Notice of Allowability

10/715,189

TSAY ET AL.

1. This is the third office action for serial number 10/715,189. This application contains 4 claims numbered 5-8.
2. Claims 5-8 as submitted on 8/18/04 are allowed.
3. Amendment to Figures 3 and Figure 4 filed on 1/12/05 has been approved.
Amendment to specification filed 1/12/05 has been entered.

FIG. 3

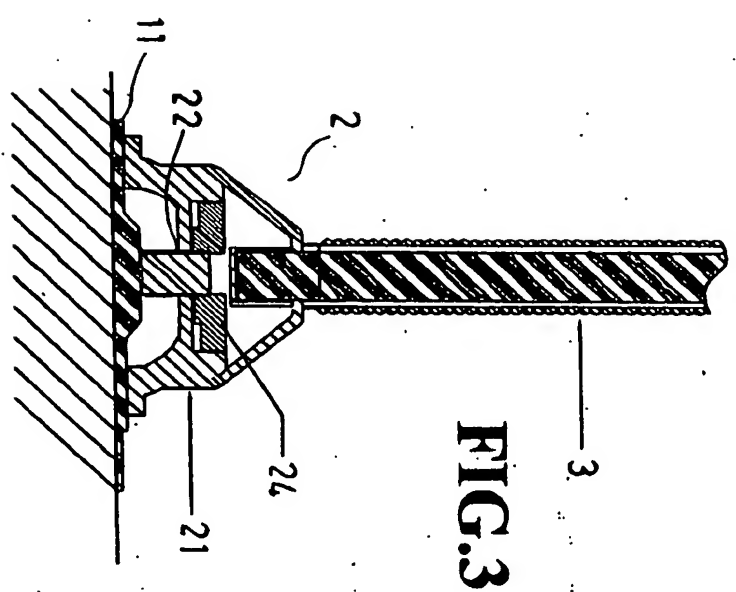
ANNOTATED MARKED-UP DRAWING

Approved
